RECEIPT DATE: 2/25/2015 **ONSITE SEWAGE DISPOSAL SYSTEM** P 555749

PROPERTY ADDRESS: 18336 Chelsea Knolls Drive, Mt. Airy, MD 21771

RE: 18336 Chelsea Knolls Drive, BAT Plan comment

BAT SITE PLAN
CHELSEA KNOLLS
LOT 14
18336 CHELSEA KNOLLS DRIVE
ZONING: RC-DEO
TAX MAP No. 12 GRID No. 5 PARCEL No. 78
FOURTH ELECTION DISTRICT HOWARD COUNTY, MARYLAND
DATE: DECEMBER, 2014
SHEET 1 OF 2

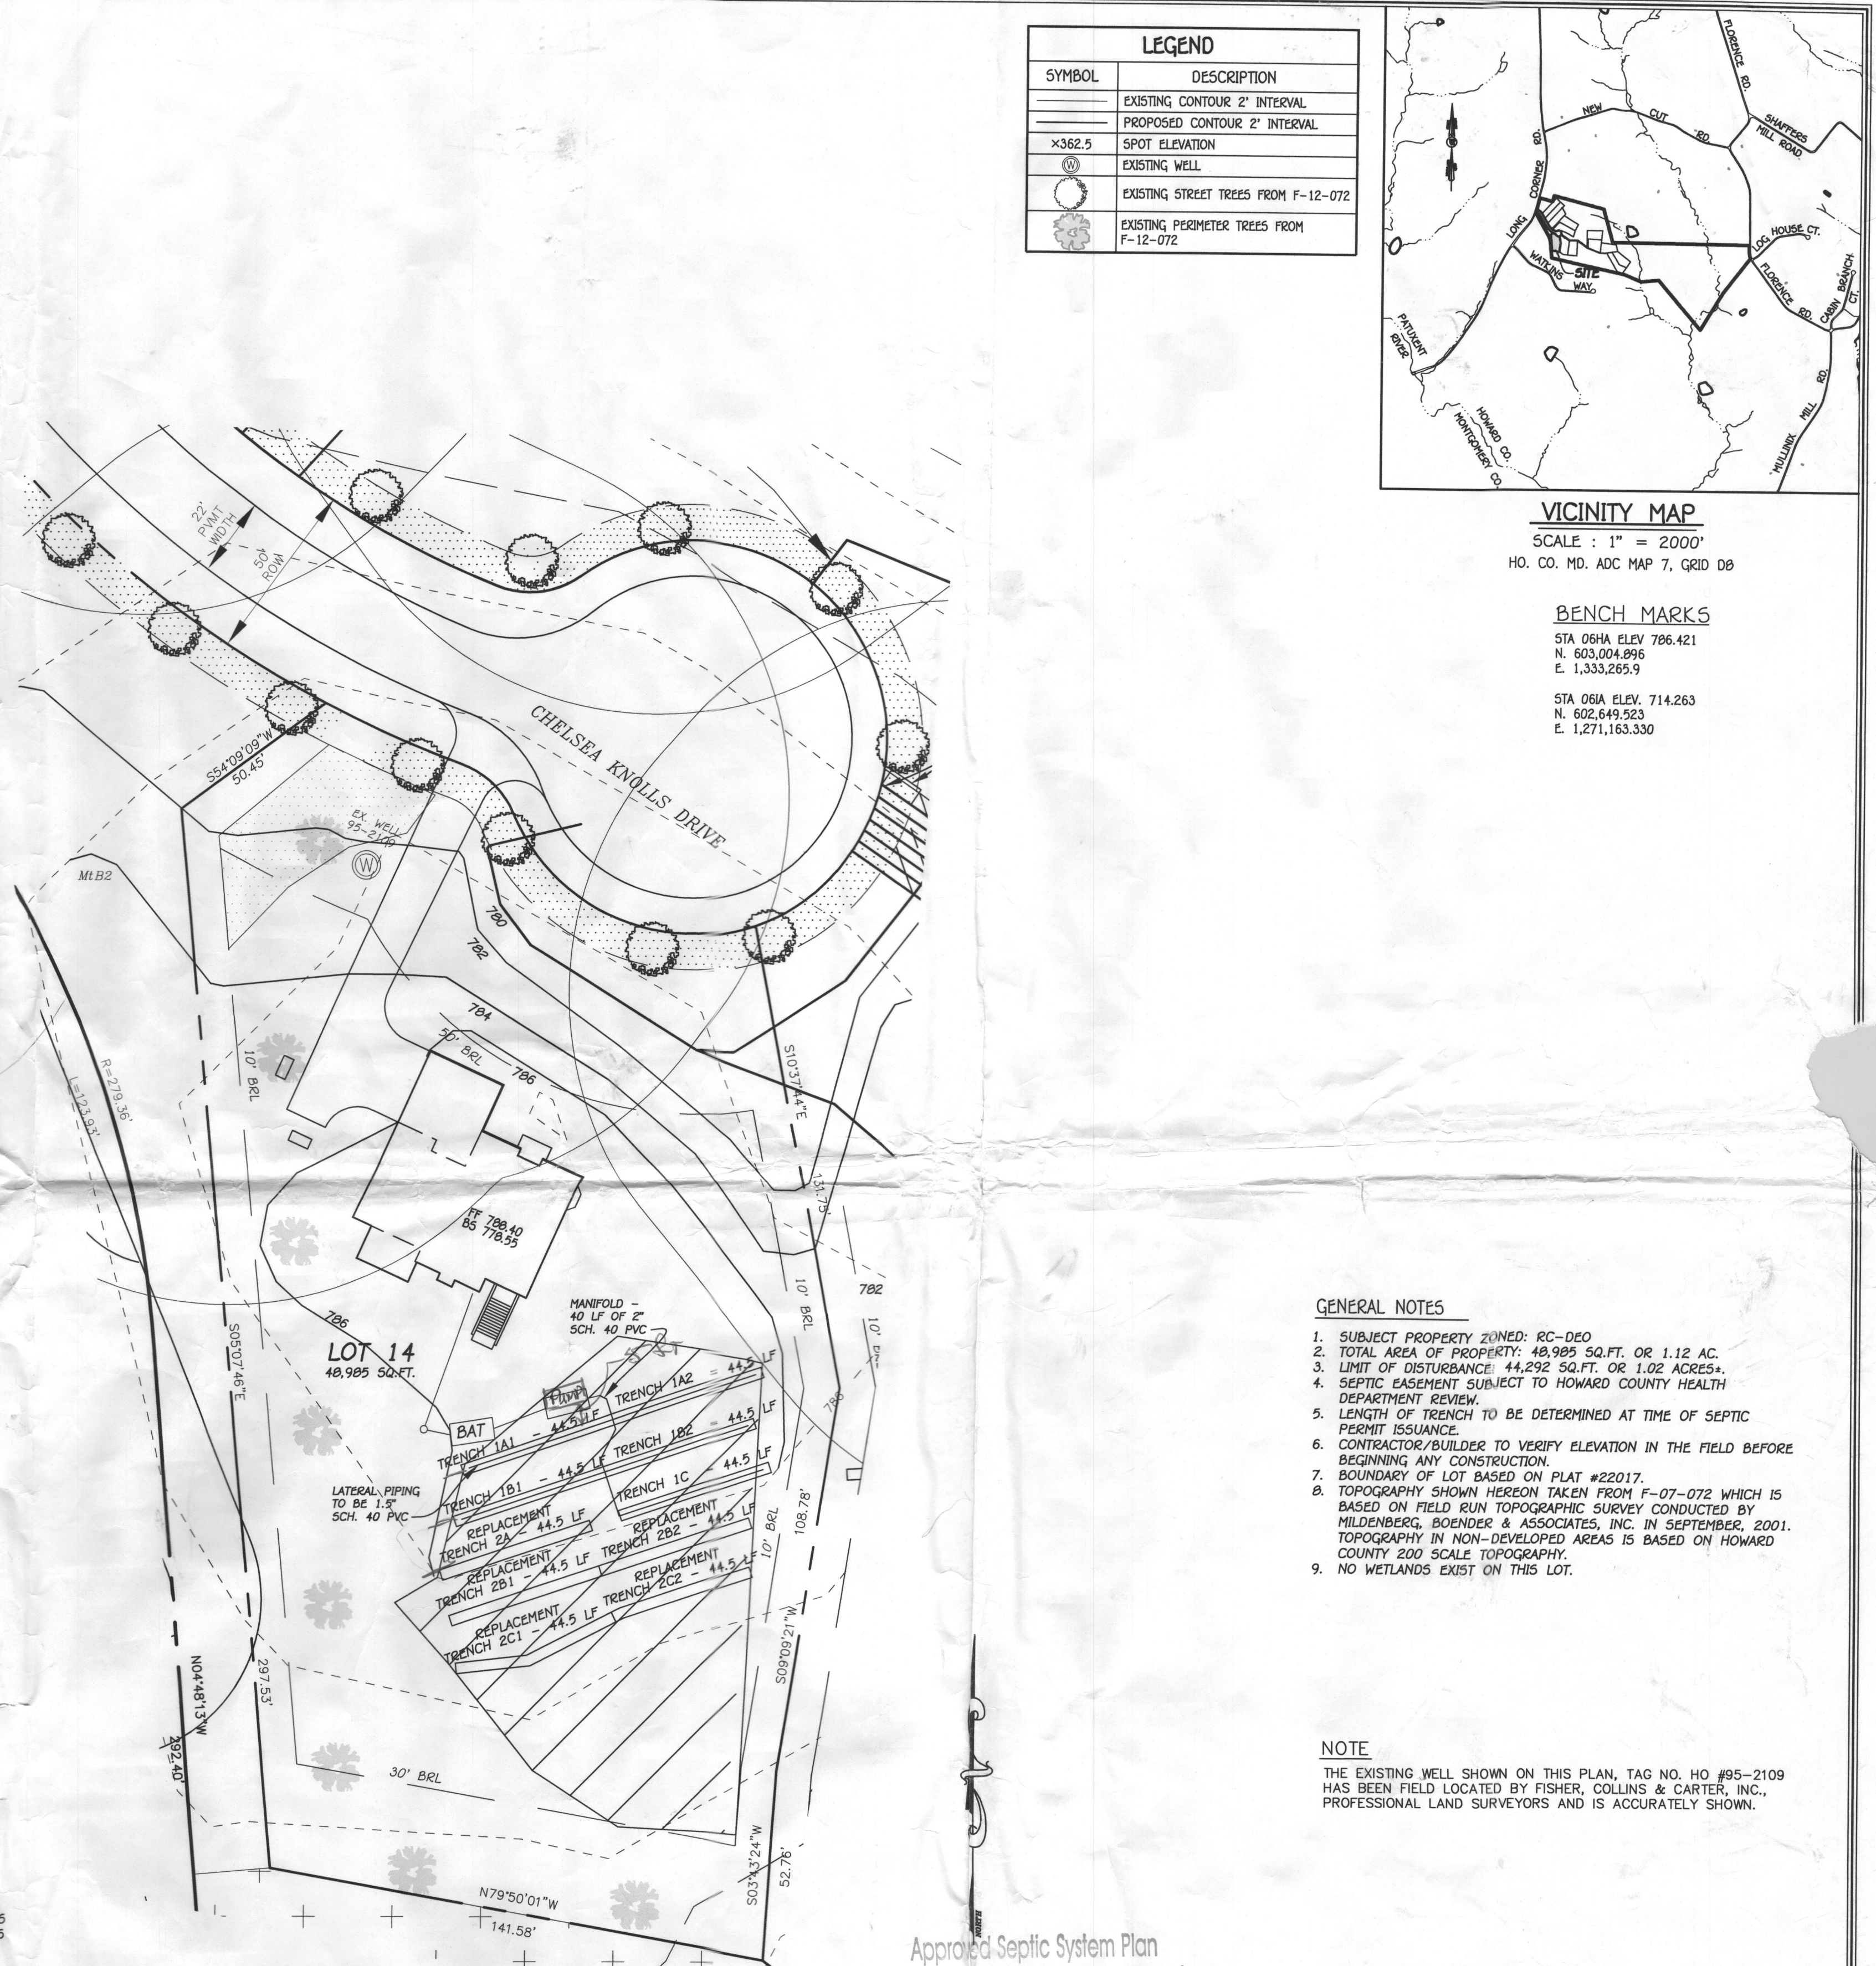
Edits are needed in the submitted BAT Plan for the subject property. See the ten (10) comments listed below.

1. Using ¼" perforations, the required Distal Head (or Discharge Head) is 3 feet.
 - a. Correct the "Head" value in both tables for Low Pressure Dosing System.

- b. Correct the "Distal Head" value in Total Dynamic Head calculation.
 - c. Correct the "Perforation Flow Rate" in both tables for Low Pressure Dosing System.

- d. Re-calculate "Trench Flow Rate" in both tables for Low Pressure Dosing System.
 - e. Correct the calculation for Total Dynamic Head.
 - f. Label the turn-up height as 3 feet in the detail for the lateral turn-up.

2. Correct the "Perforation Spacing" values in the table for Initial System. There is the same number of perforations in each lateral so there should be no difference in the spacing between perforations.

3. The "Pipe Volumes" constant for 1.5-inch pipe is incorrect. Correct the value and re-calculate Pipe Volumes and Minimum Dose.
4. The diameter of the Force Main-Manifold is too small and will result in a flow velocity of about 11 feet per second or a little more. A larger pipe diameter such as 2-inch is recommended.

5. Specify the type of pipe, e.g., 'SDR26' or 'SCH 40', for the Force Main/Manifold, and 'SCH 40' for the Laterals, respectively.

The submitted building permit for this proposal designates that a 5-bedroom residence is proposed. The BAT-LPD Plan submitted to the Health Department is for a 4-bedroom residence. Revise and resubmit an appropriate plan for the proposed structure.

Please know that the BAT unit is too close to the areaway. The areaway is interpreted as being part of the foundation. Both the BAT unit and the Pump Tank must be 20 feet distance from the areaway.
